### **ADDENDUM NUMBER 1:**

### CITY OF PORTSMOUTH, NEW HAMPSHIRE SAGAMORE AVENUE RECONSTRUCTION PHASE I

#### Issued: June 27, 2014 For Bids Due: July 2, 2014

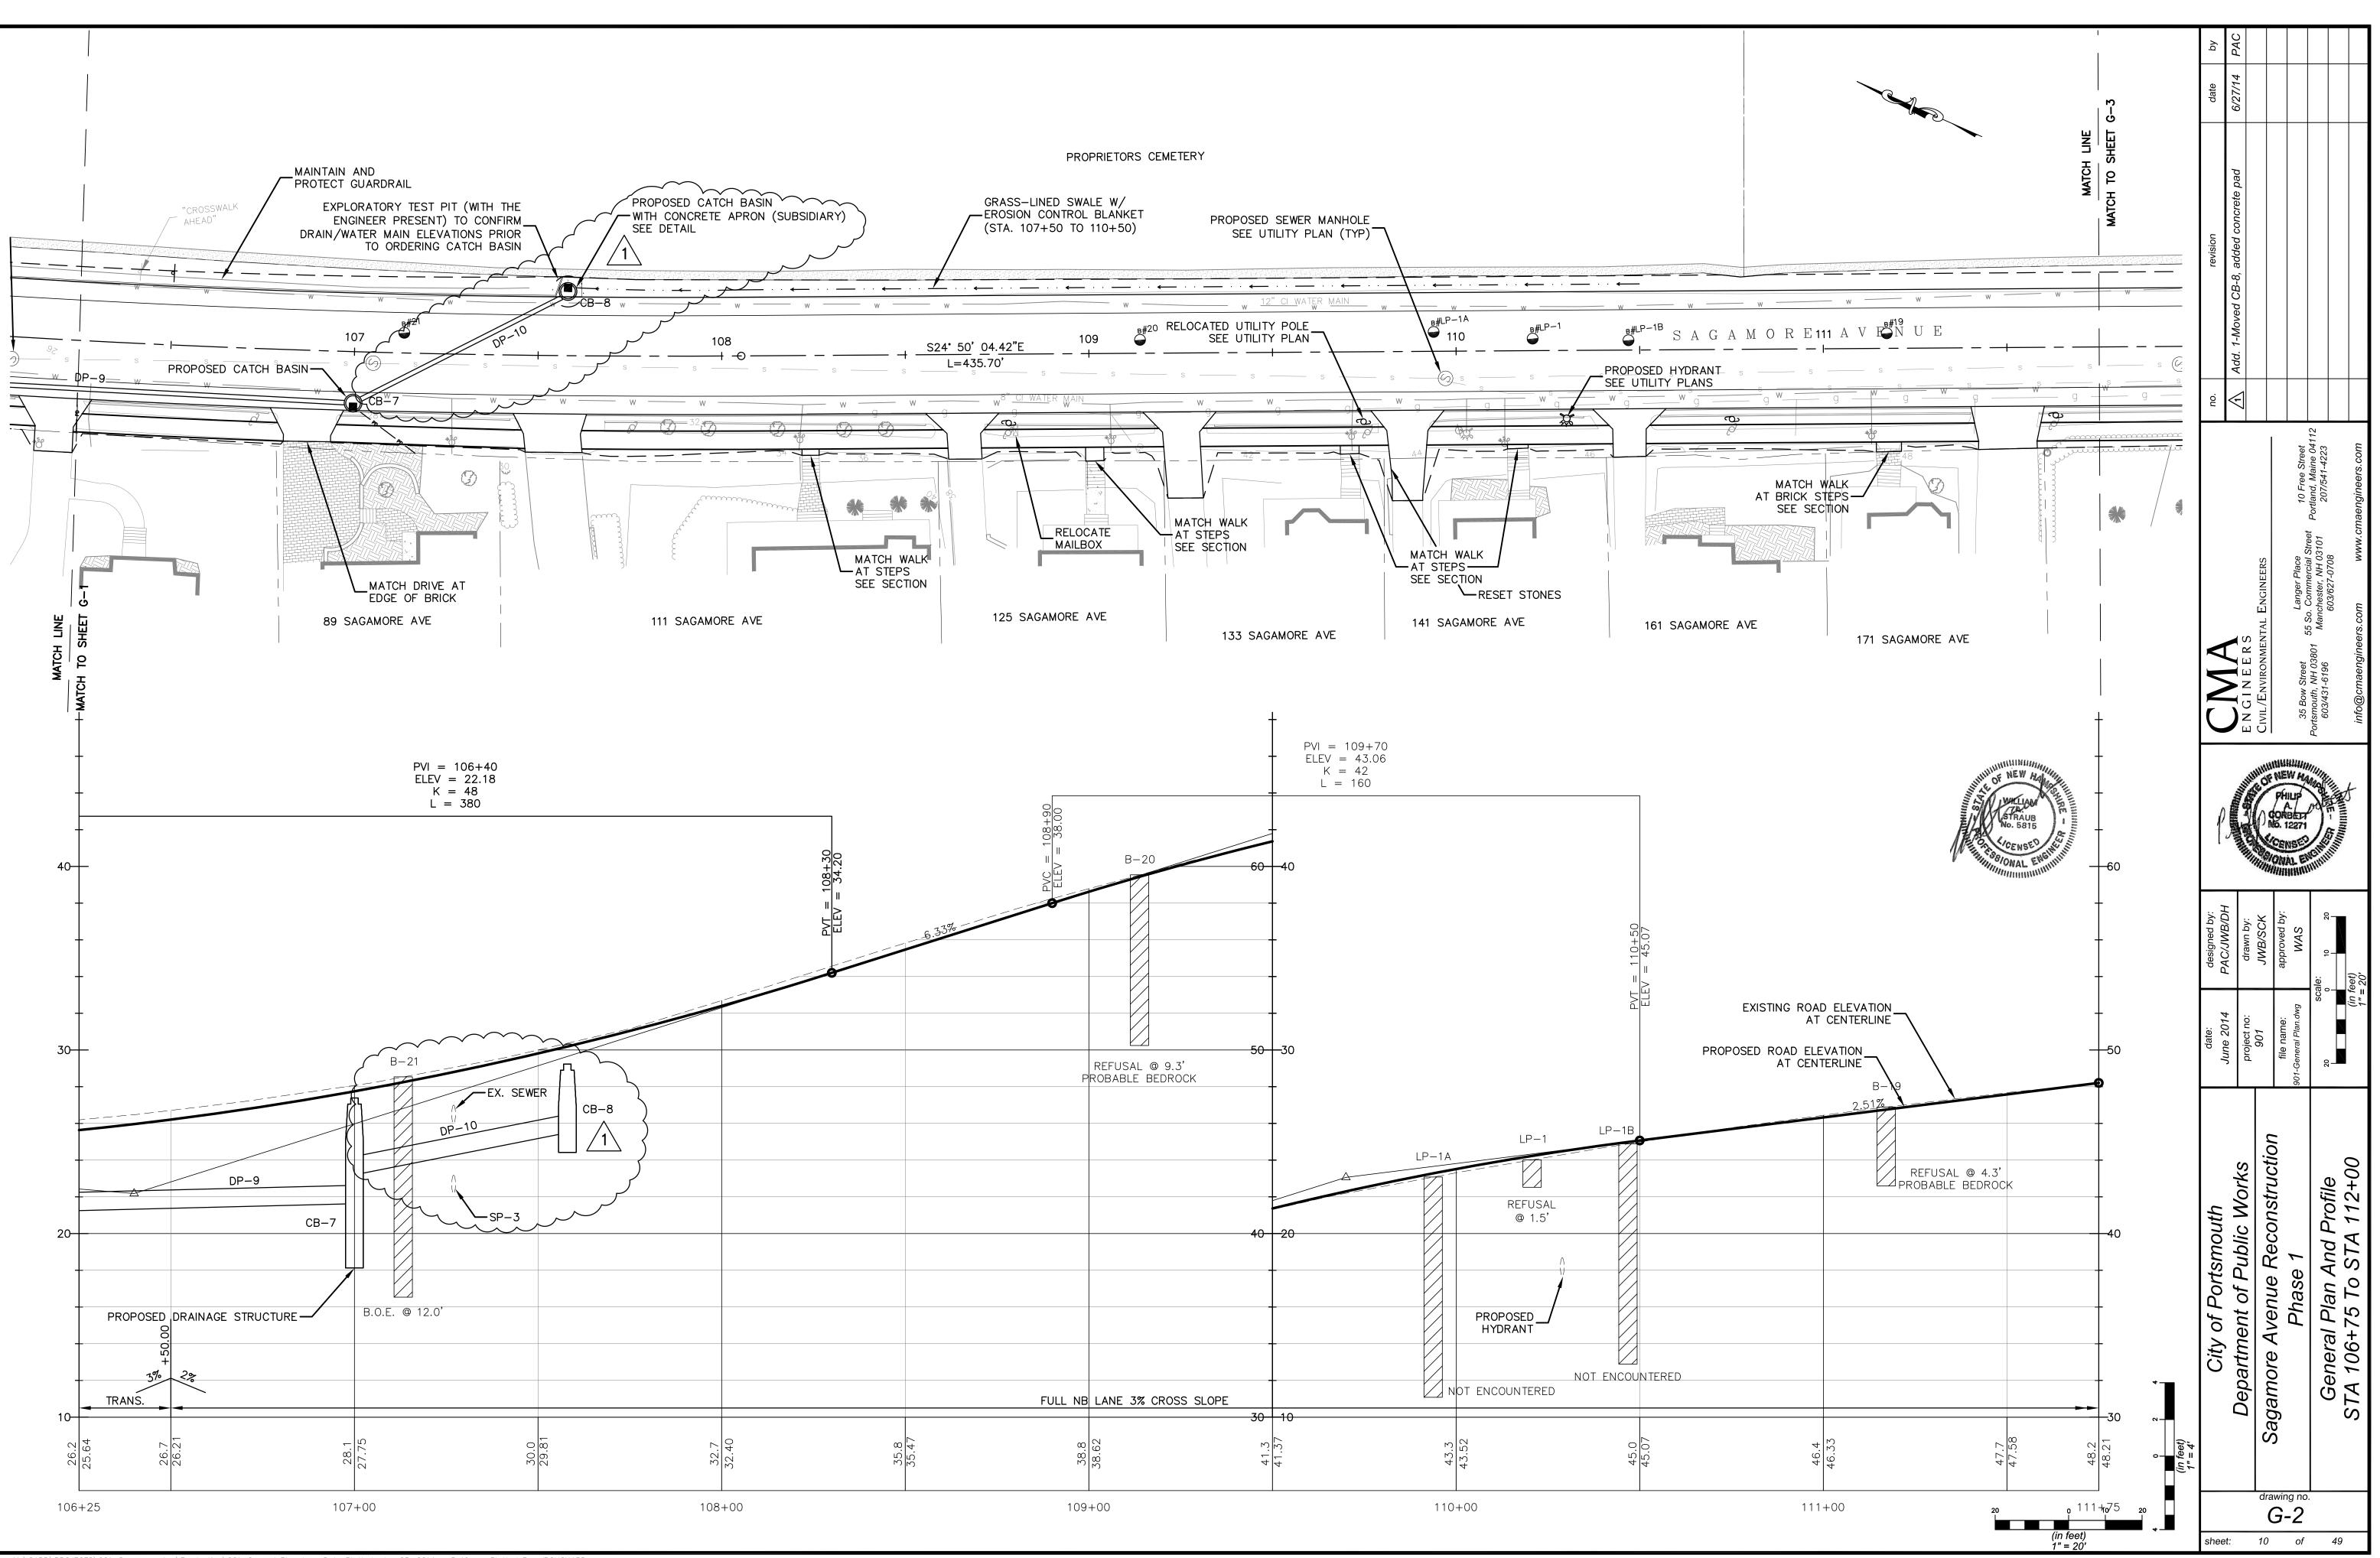
#### 3. Sheet G-2 - General Plan & Profile:

CB-8 and DP-10 have been relocated to the location shown in the attached plan sheet. CB-8 now includes a concrete apron, incidental to the cost of the catch basin.

#### 2. <u>Sheet N-3 – Drain and Sewer Notes</u>:

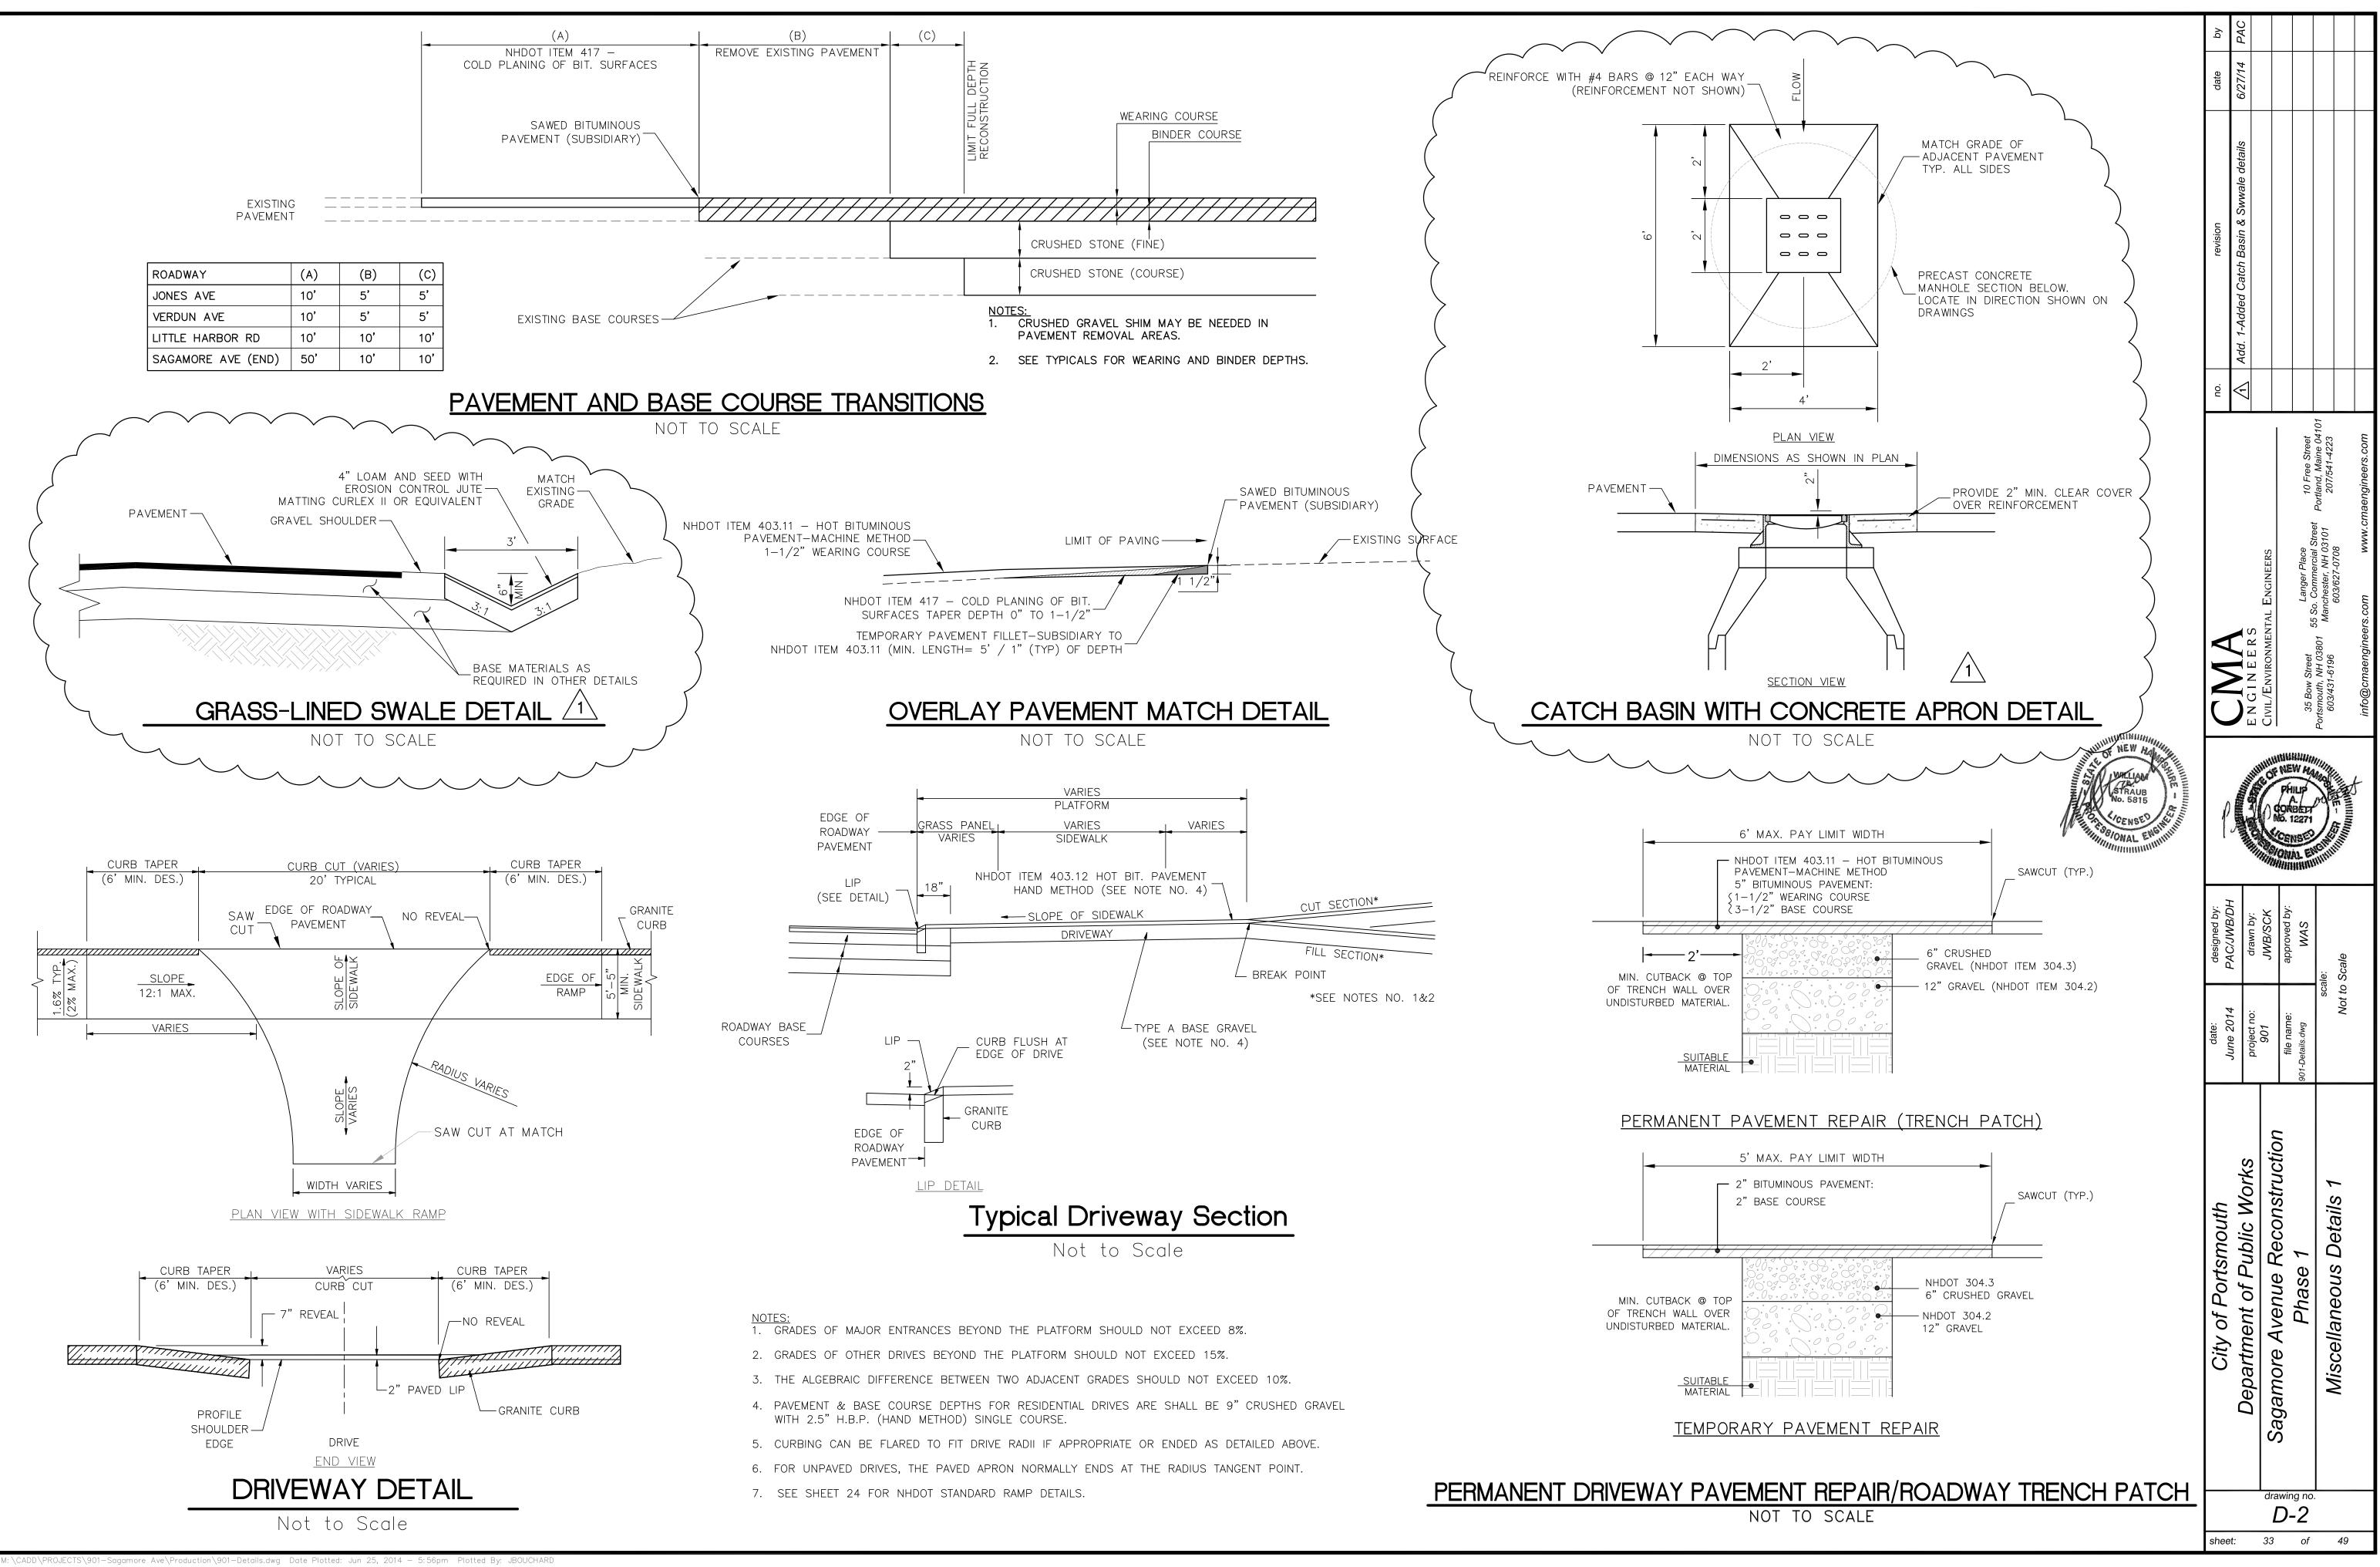
CB-8 and DP-10 utility notes have been modified as shown in the attached plan sheet.
